EMBARC

June 3, 2021

**Re: 91 Beatrice Circle 40B, Belmont MA
Preliminary Architectural Peer Review Response**

JOB NUMBER: 19.085 SHEET 2 OF 11

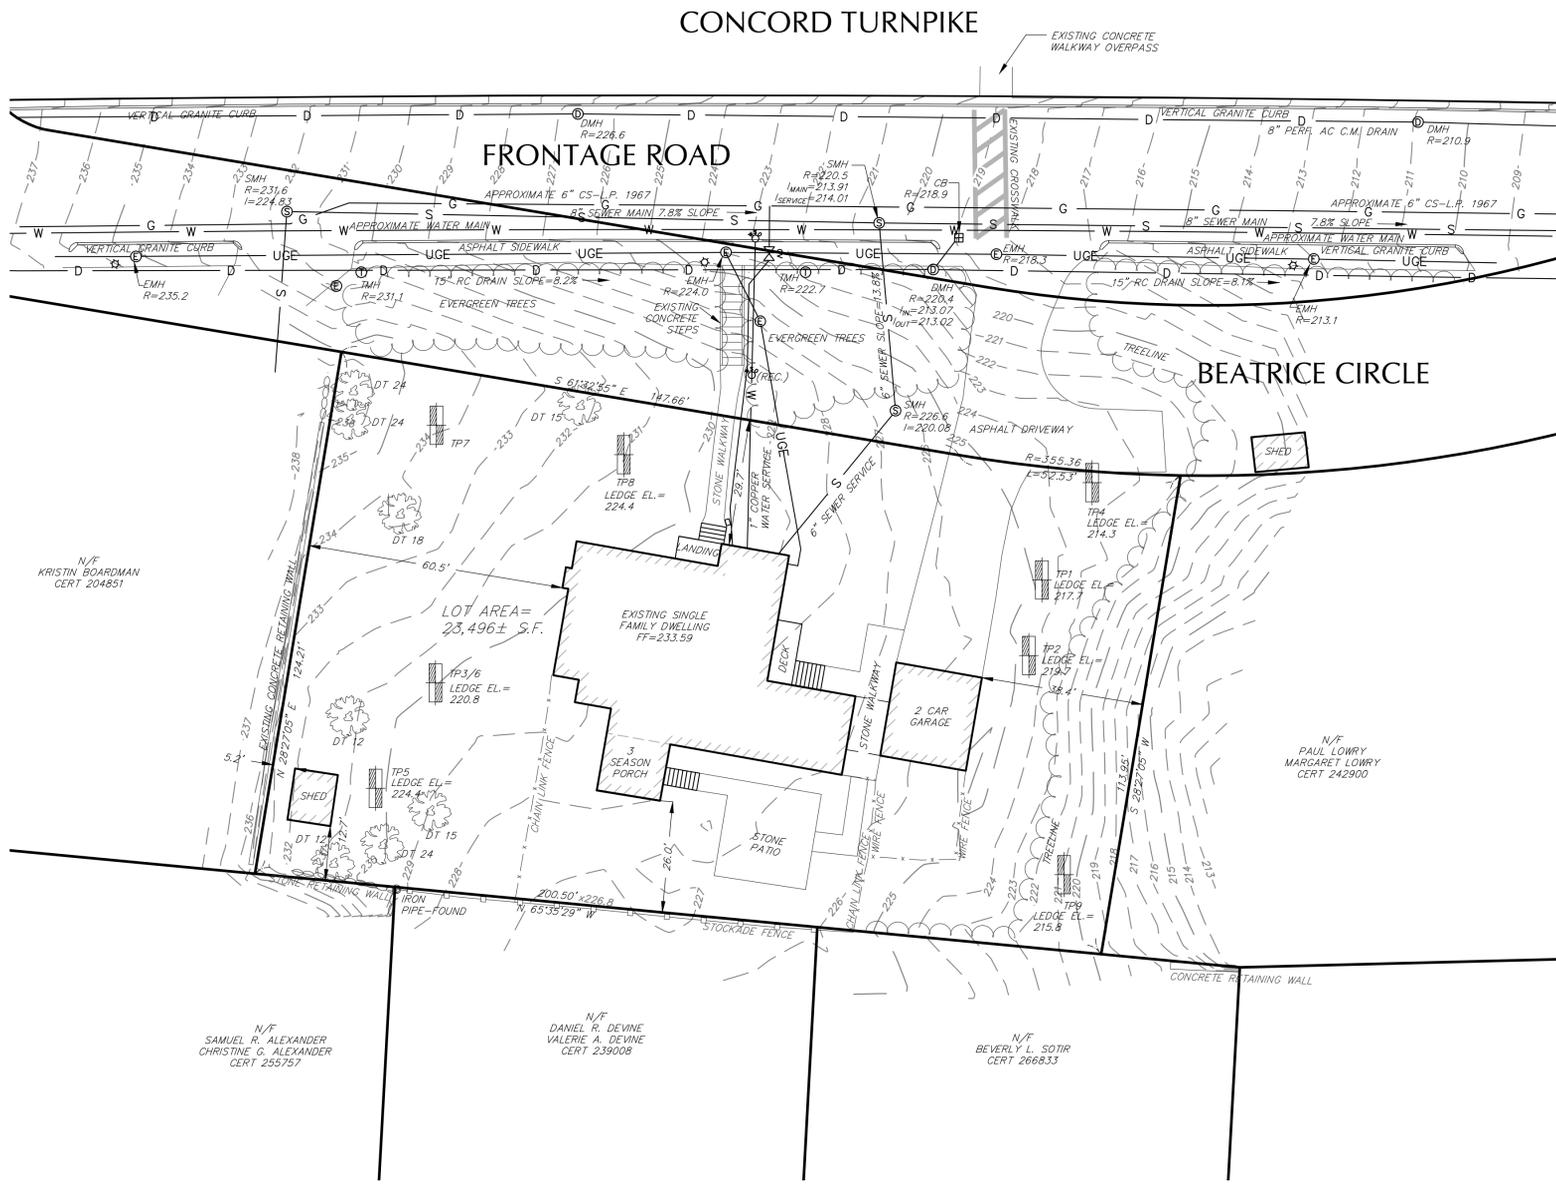
2. DBS states “Despite the soil mapping calling for “A” soils (Charlton) DBS calculated land coverage numbers (CN) using Hydrologic Group “C” soils based upon soil evaluations performed within the vicinity of the project.”
 - a. Weston & Sampson does not agree with this assumption. DBS stated in their existing conditions summary that on-site test pits were used to confirm the Natural Resources Conservation Service (NRCS) mapping. Test pit logs included on the Existing Conditions Plan (Sheet 2 of 8) of the Site Plans identify parent soils as “Fine Loamy Sand”. The NRCS classification for Charlton and the Rawls Rate soil classifications summarized in the Massachusetts Stormwater Handbook state that Loamy Sand is HSG A. HydroCAD modeling and recharge volume calculations should be updated for this site based on an existing conditions soil classification of HSG A.

DBS Response: Six additional soil test pits were conducted on May 12, 2021. The additional test pit data can be found on sheet 2 of the site plan.
